- NOTES TO LOCKER ROOM - REVISIONS REQUIRED BY CHANGE ORDER NO. 1 - ADDITION TO HIGH SCHOOL.
- NOTE 1 - GENERAL MECHANICAL AND ELECTRICAL CONTRACTORS: LOCKER ROOM AREAS SHALL BE CONSTRUCTED AS SHOWN ON THIS SHEET, IN LIEU OF PLAN SHEET A2.

DESIGN	JOS
DRAWN	WJE
DATE	OCT. 1979
FILE NO.	78-508
SHEET NO.	C-0-1-1

ADDITION TO HIGH SCHOOL
UNIFIED SCHOOL DISTRICT #320
WAMEGO, KANSAS

REVISION	DATE	BY
CHANGE ORDER NO. 1 REVISIONS	10/31/79	RAC

PLAN OF GROUND FLOOR ROOMS 145-148, 151, 152, 156-159, 162 & 163
SCALE: 1/4"=1'-0"

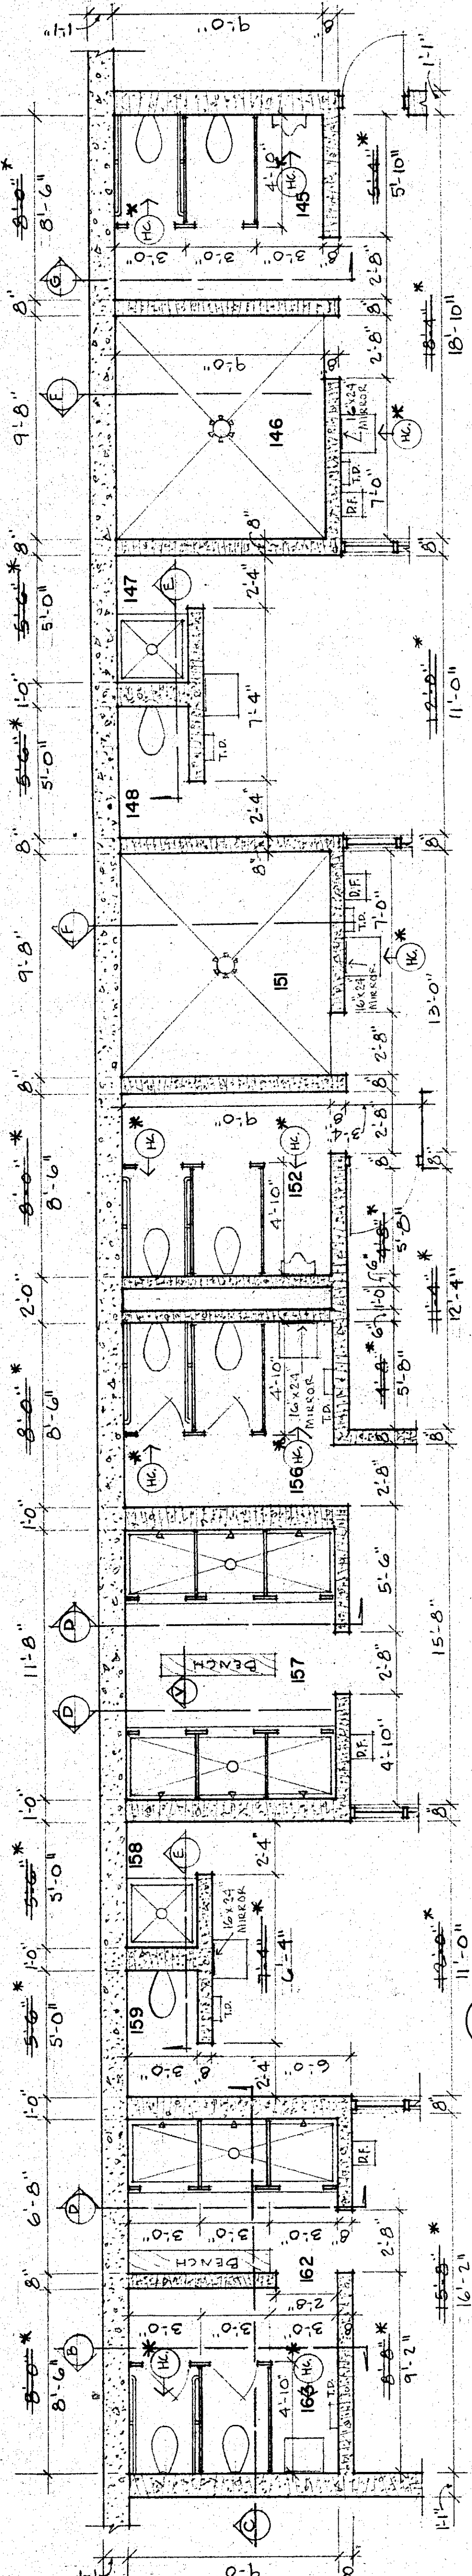
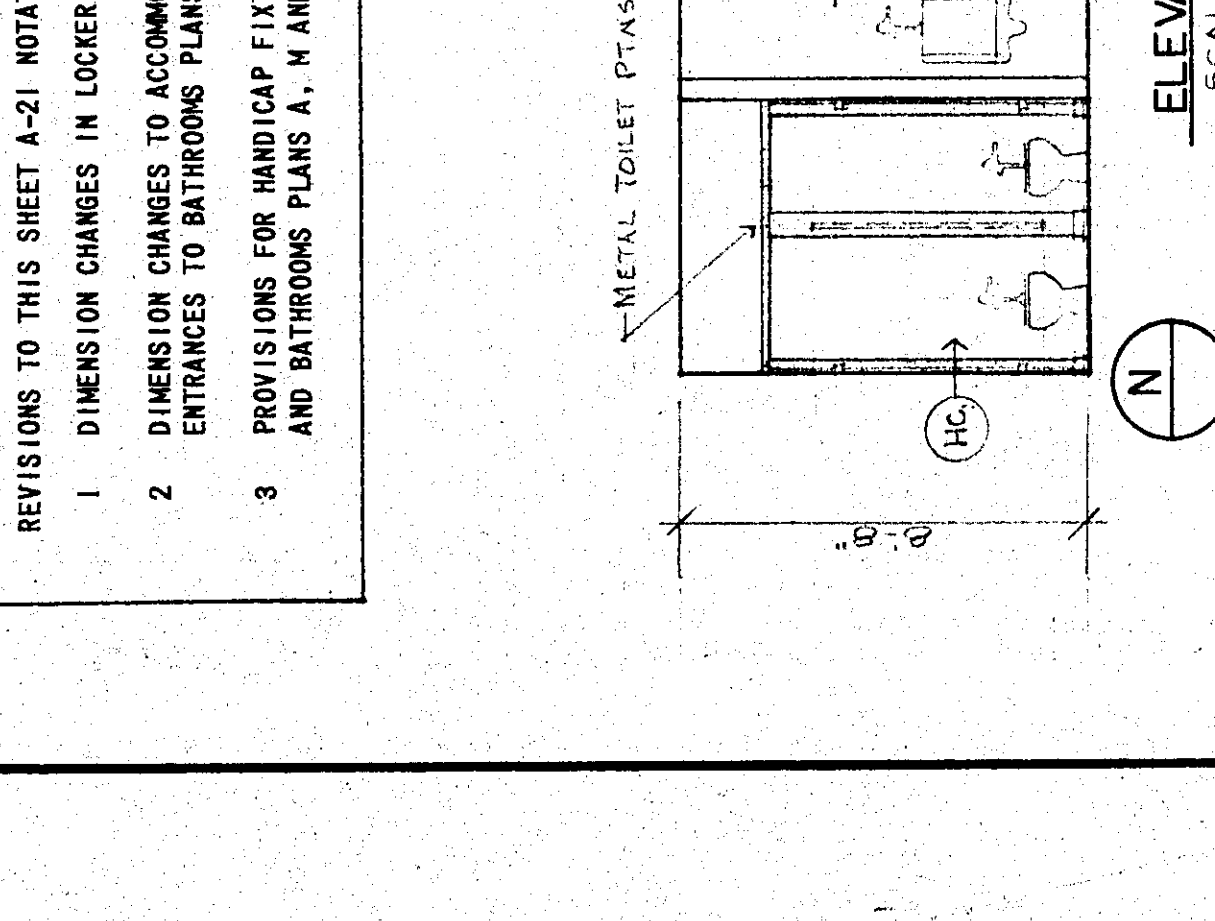
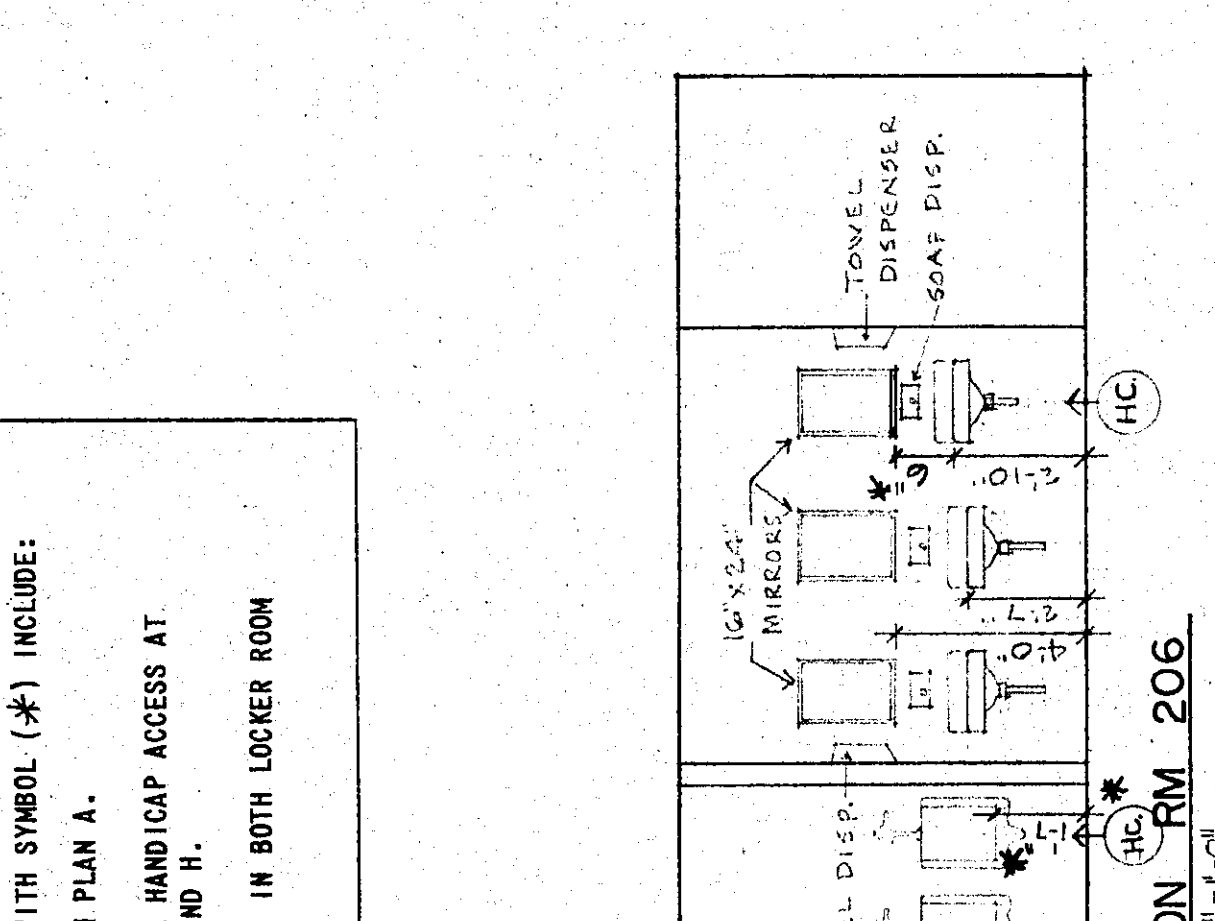
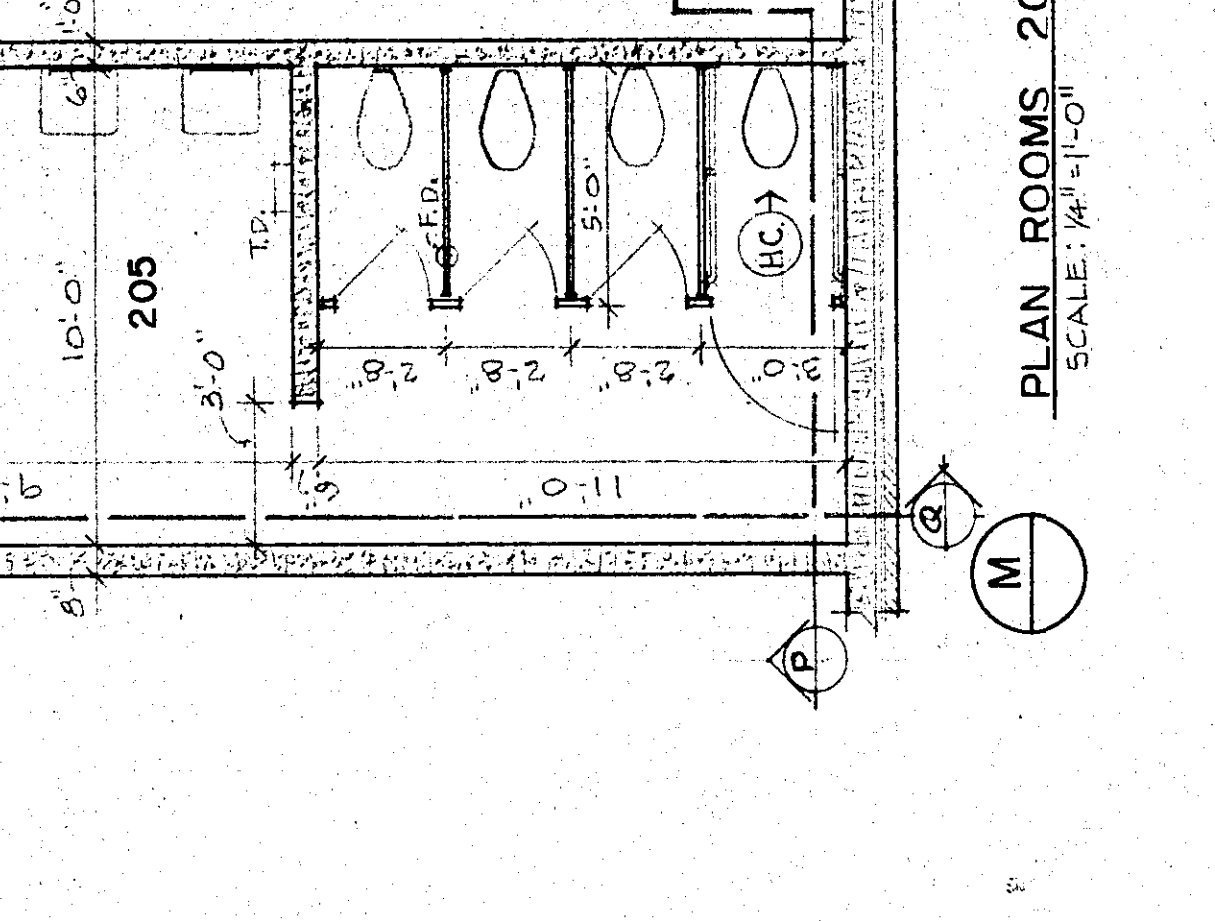
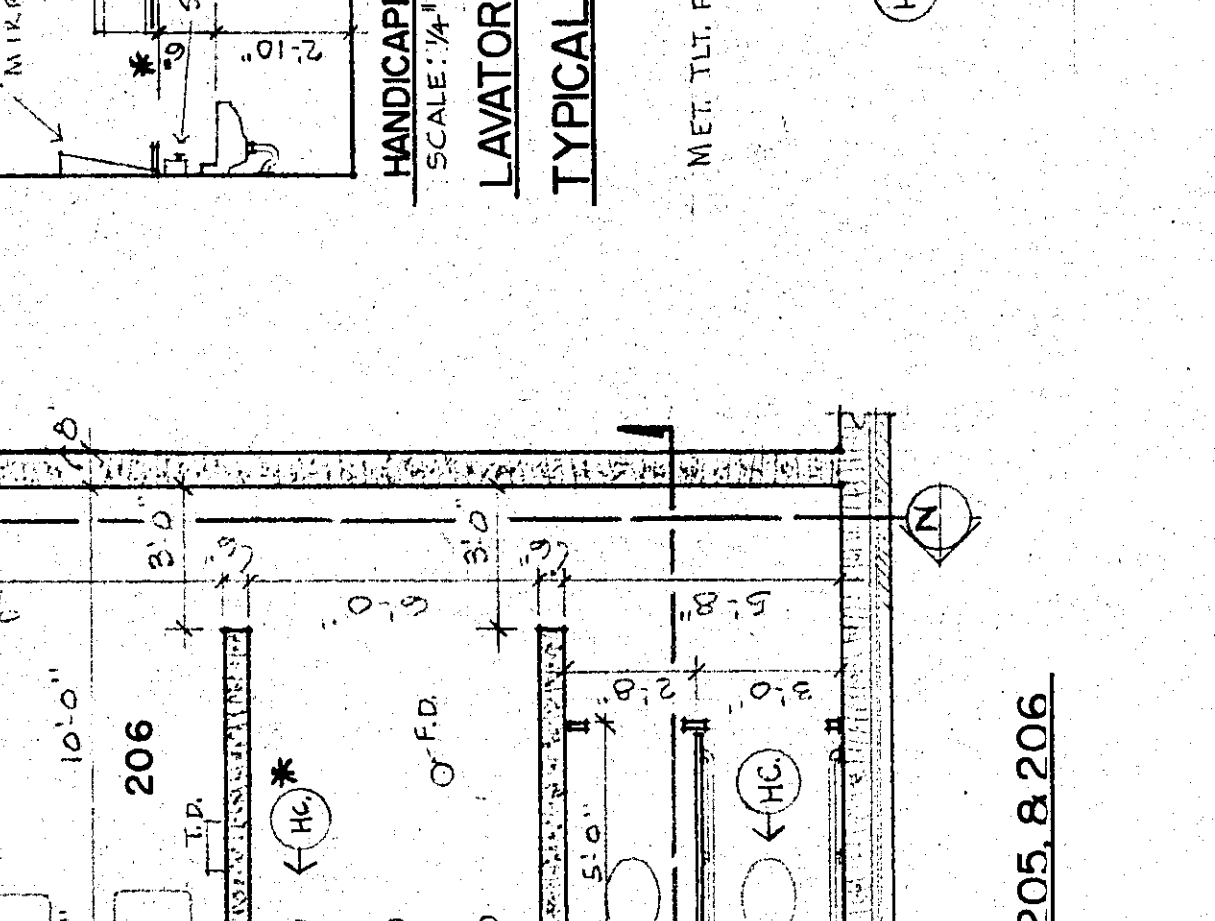
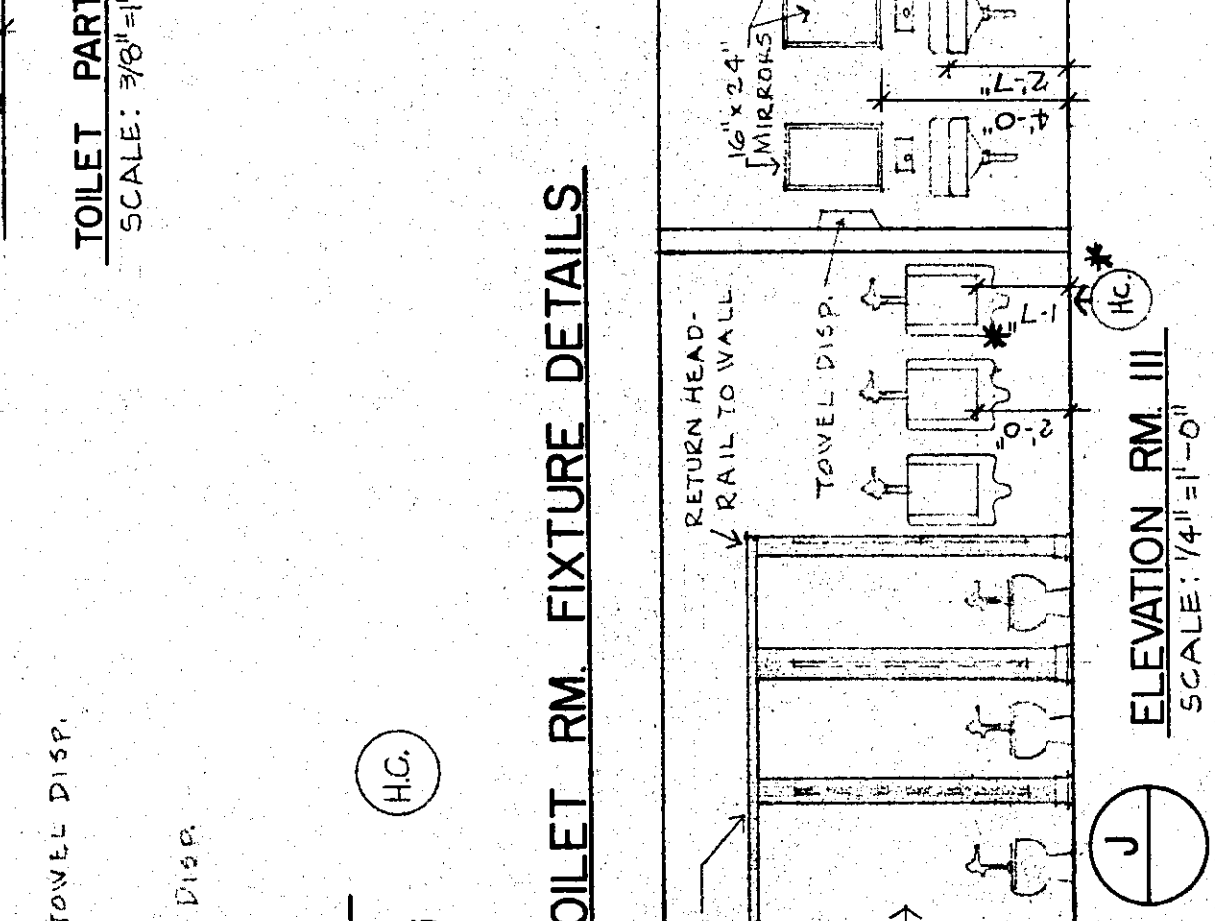
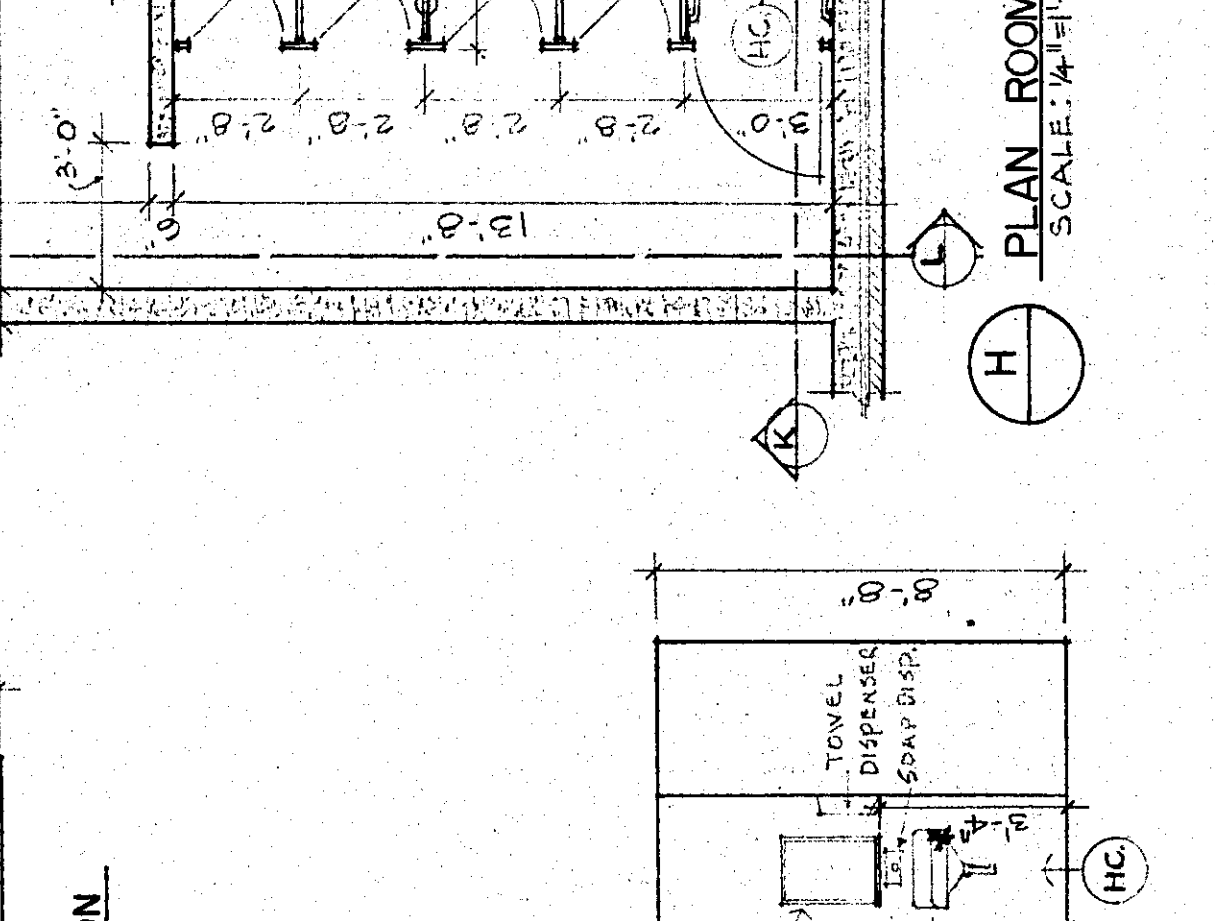
REVISIONS TO THIS SHEET A-21 NOTATED WITH SYMBOL (#) INCLUDE:

- 1 DIMENSION CHANGES IN LOCKER ROOM PLAN A.
- 2 DIMENSION CHANGES TO ACCOMMODATE HANDICAP ACCESS AT ENTRANCES TO BATHROOM PLANS M AND H.
- 3 PROVISIONS FOR HANDICAP FIXTURES IN BOTH LOCKER ROOM AND BATHROOM PLANS A, M AND H.
